# CITY OF CONWAY, ARKANSAS HISTORIC DISTRICT COMMISSION

## HISTORIC DISTRICT COMMISSION

April 25, 2022

**1 NORTH ELEVATION**  
1/4" = 1'-0"

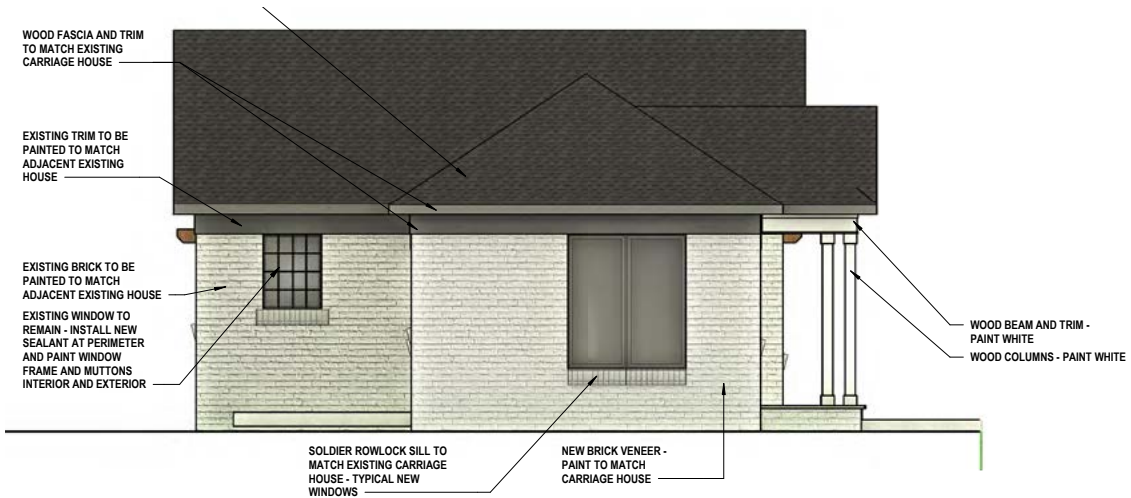
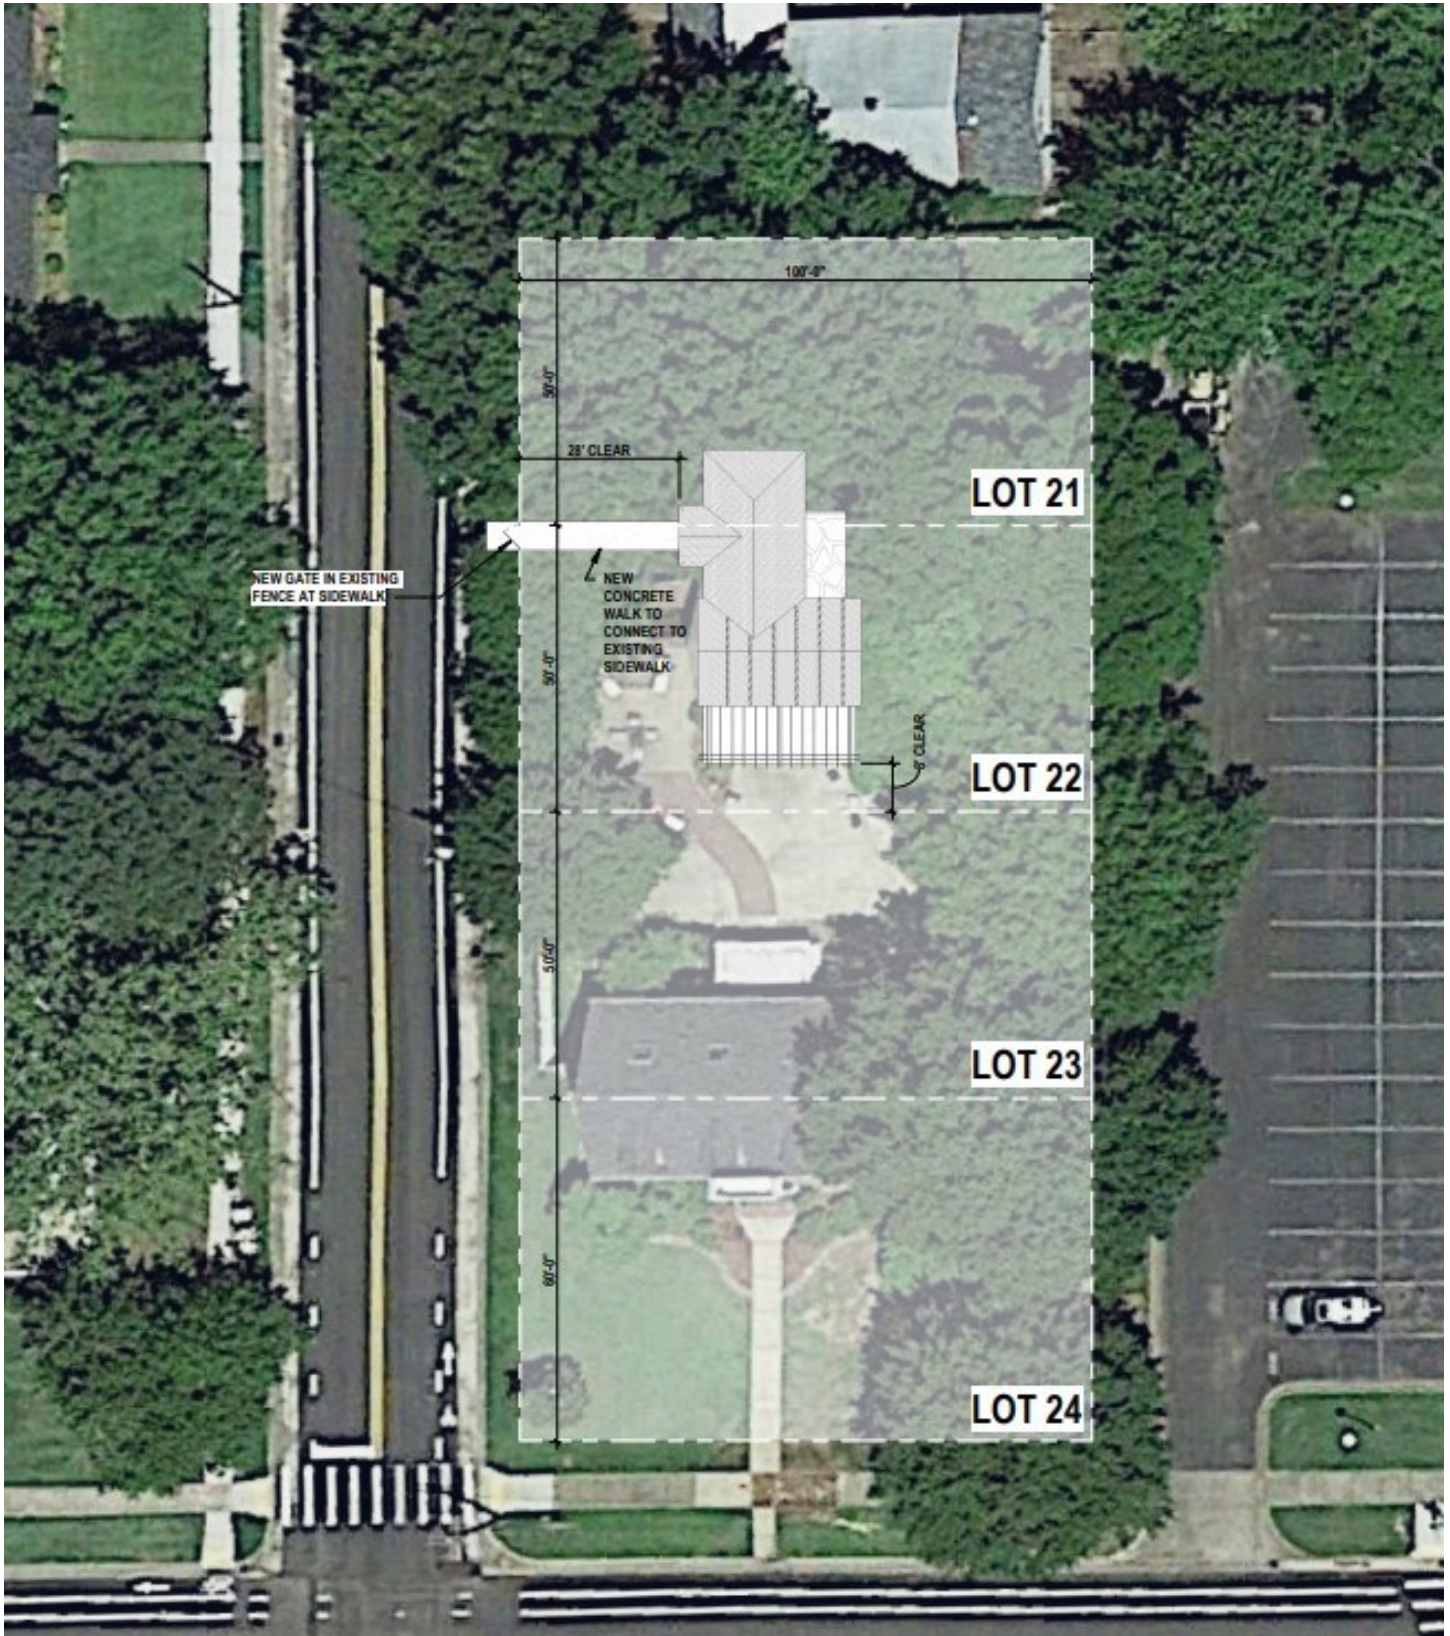
*The applicant is proposing to retain the existing 8 over 8 windows in the structure. New windows on the addition are proposed as single light casements. This use type is not common in the district. For the north and west elevations recommend requiring one-over-one single or double hung windows of a size matching the existing window. The remaining windows will not be viewable from the street and not reviewable.*

*The applicant's proposed addition will maintain a roof form appropriate to the structure. Recommend requiring the gable for the new entry be the same form and materials as the existing gable.*

1. For the north and west façade, windows will be required to be single or double hung one over one windows and maintain a size matching the existing window on the west façade. A double window on the north façade is appropriate.
2. Require the gable for the new entry match the form, style, and materials of the existing gable on the west façade.
3. All fascias and soffits shall be constructed with wood or wood-like materials such as Hardie® siding.
4. All HVAC equipment shall be screened or placed along the east façade of the structure.
5. The applicant will provide revised plans to the Planning Director for review and approval prior to issuance of building permits.
6. Replating of the property shall be required prior to issuance of a certificate of completion and issuance of a short term rental license.

FRONT ELEVATION

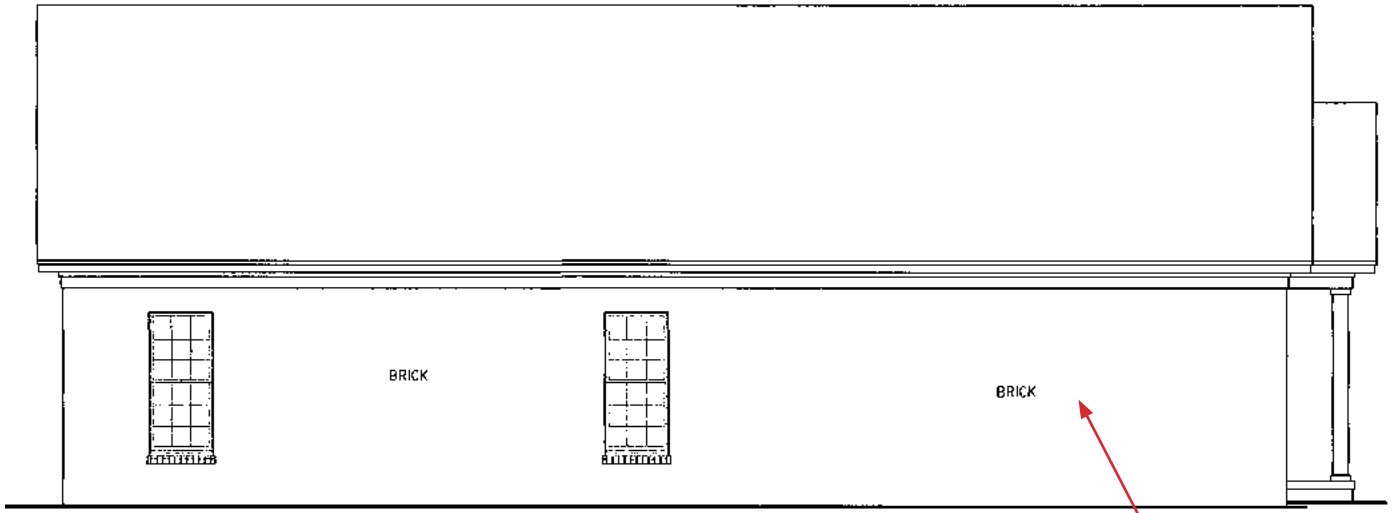
*The front façades will be composed of 16% windows and openings, which does not appear appropriate. Recommend requiring an additional window or a double window on the front façade for each bedroom 3, and require a full size window in bedroom 3 along each side façade. Also, recommend requiring the house plan for the west lot be flipped to require the proposed east façade to face Neal St, as this façade features more windows.*

Add an additional window  
or double window on  
Bedroom 3 front façade

6. Require an additional full size window or double window on the front façade of each structure in bedroom 3.
7. Require an additional full size window along the side façade of each structure for bedroom 3.

RIGHT ELEVATION

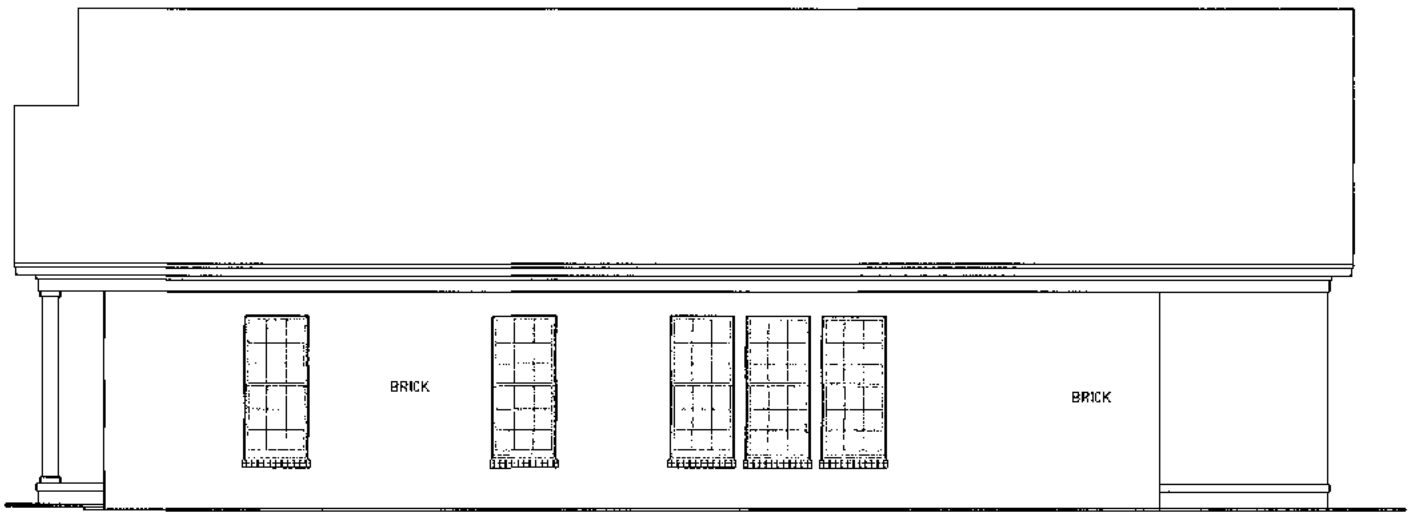
Add a full-size window on  
Bedroom 3 side façade

1 ARCHITECTURAL SITE PLAN  
SCALE: 1" = 20'-0"

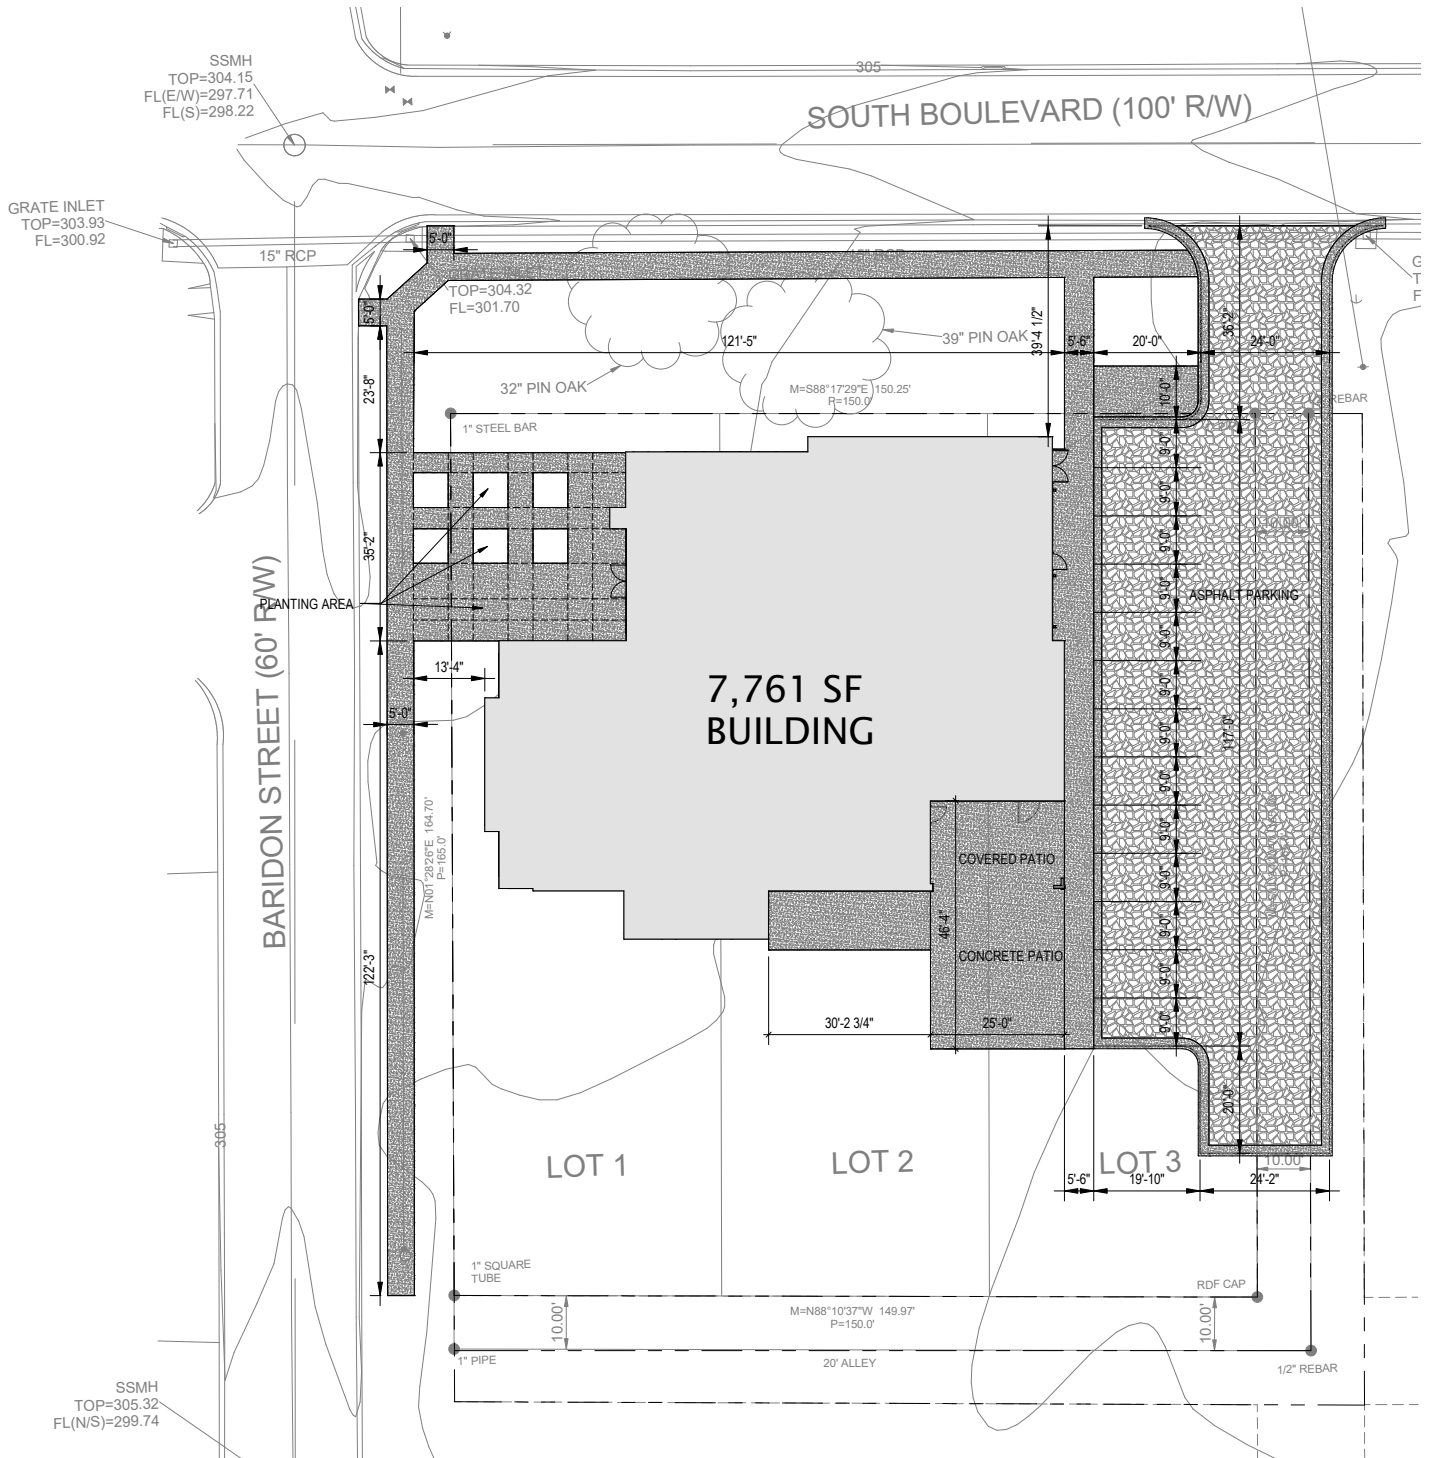
*Proposed parking is appropriately located. Recommend requiring a low brick wall to screen parking areas along South Blvd and require the removal of the space closest to South Blvd. This space may be replaced further to the south. This requirement is intended to make the structure a stronger leading to the street than the parking area.*

5. Require a 36" brick wall to screen parking areas along South Blvd.
6. Platting of the property will be required.
7. A conditional use permit allowing Religious Activities will be required prior to site development review approval.
